**Re: Peer Review, Hunder Development Ltd. – Hunsberger Pit Acoustical Study
Field Study Report (Final)
Novus Project No. 11-0006**

Novus Environmental was retained by the Conestogo-Winterbourne Residents Association (CWRA) to conduct a peer review of the noise assessment work conducted for the proposed Hunder Development Ltd. "Hunsberger Pit". This letter presents the results of our findings, and includes the results of additional noise measurements conducted along Golf Course Road.

Figure 2: Long-Term Ambient Noise Monitoring Results

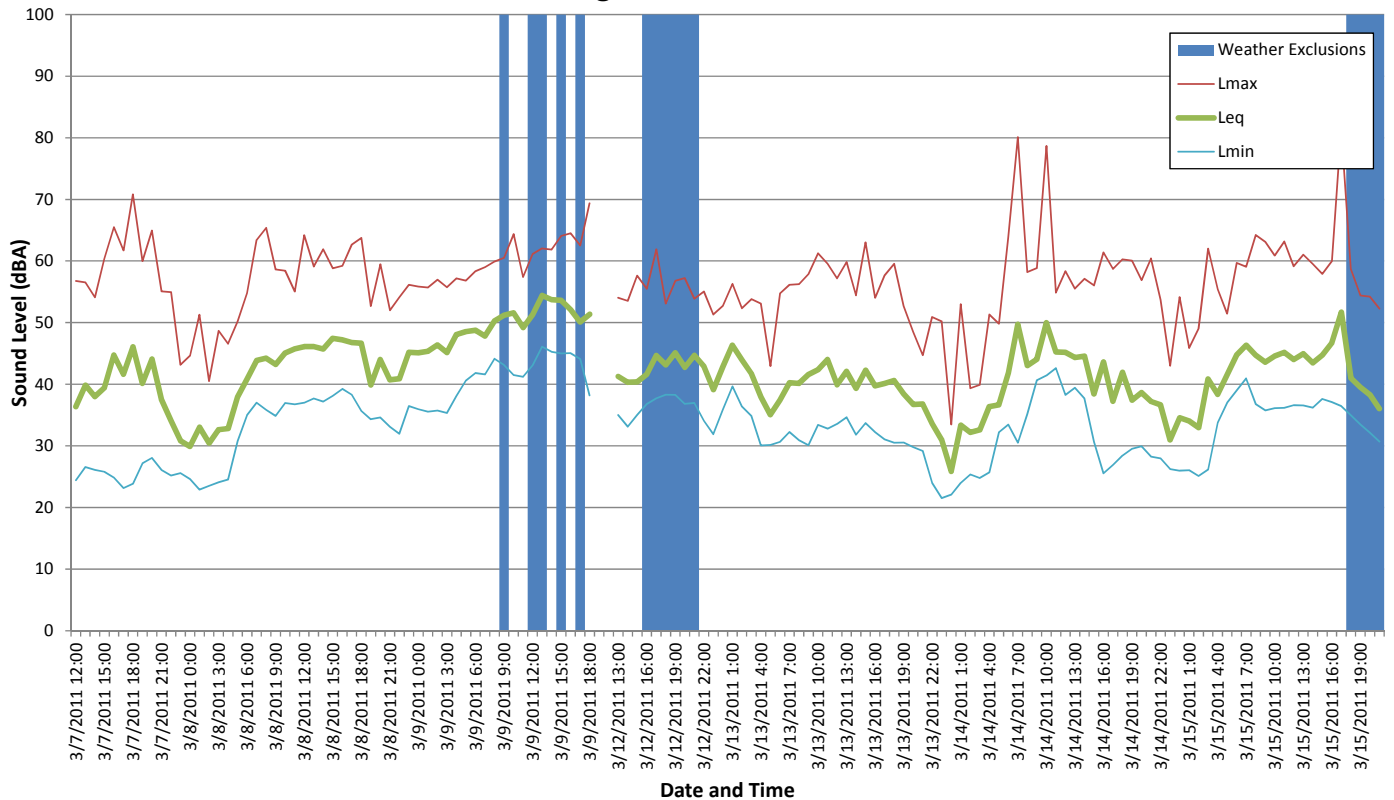
Figure 2 illustrates that during daytime and night-time hours, existing L_{eq} (1 hr) sound levels fall well below the 45 dBA daytime / 40 dBA night-time sound level minima. The minimum measured hourly levels are:

These low levels are well below the Class 3 area guideline minima, and indicate that NPC-232 Class 3 limits should apply to these receptors.

Based on the data collected to date, the criteria used in the assessment are 5 dB too lenient in the IBI report. The Class 3 limits of 45 dBA daytime / 40 dBA night-time should apply to the local receptors.
